REMARKS

IN THE DRAWINGS

FIG.2

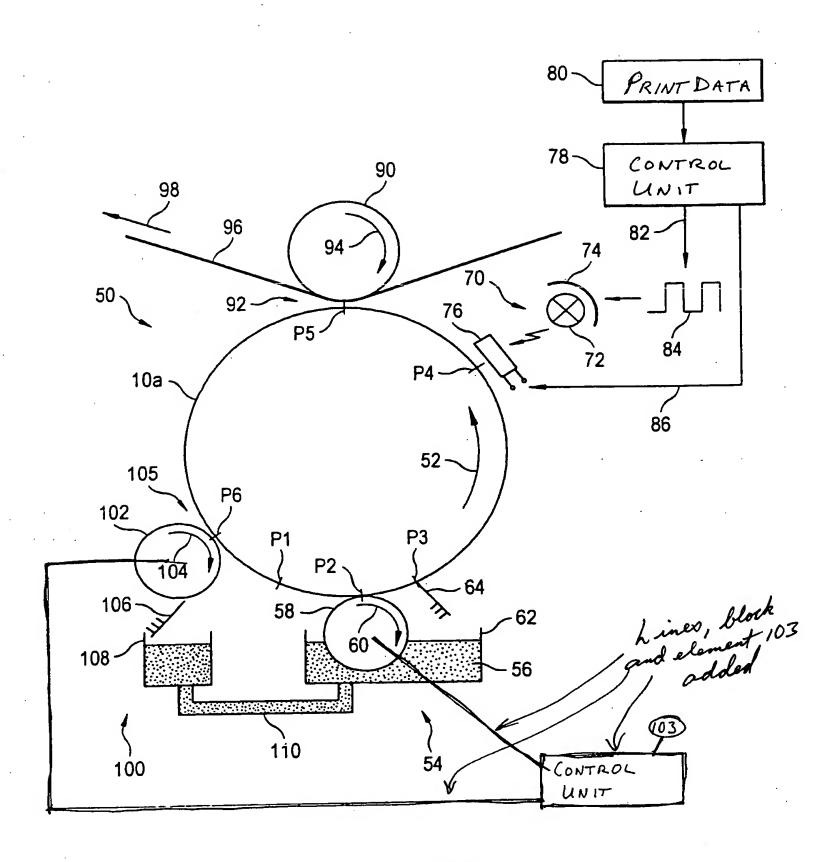
A proposed drawing change is submitted herewith which adds to the drawing only that which is already disclosed in the original application. In other words, a control unit, indicated as mere block element on the drawing, is added to the drawing to illustrate the control unit as it is claimed in the original claim and that is described in the specification and claim 34 as filed upon U.S. national stage entry. Lines from the control unit to the cleaning station and the inking station are added to the drawing to indicate that the control unit is operable to actuate the cleaning station and the inking station as described in the specification as filed upon national stage entry and as claimed in the original claim 13 filed in the International Application and replacement claim 34. As such, the added block element and two lines do not constitute new matter in the application but only show that which was already disclosed and described. A reference numeral 103 has been added in the drawing to facilitate comparison of the written description to the drawing. Applicants respectfully submit that no new matter is added by the addition of the reference numeral. As such,

Enclosed is an amended Figure 2 marked "Replacement Sheet" showing the change described above. Also enclosed is a copy of the Figure 2 marked to show the changes, which sheet is marked "Annotated Sheet Showing Changes."
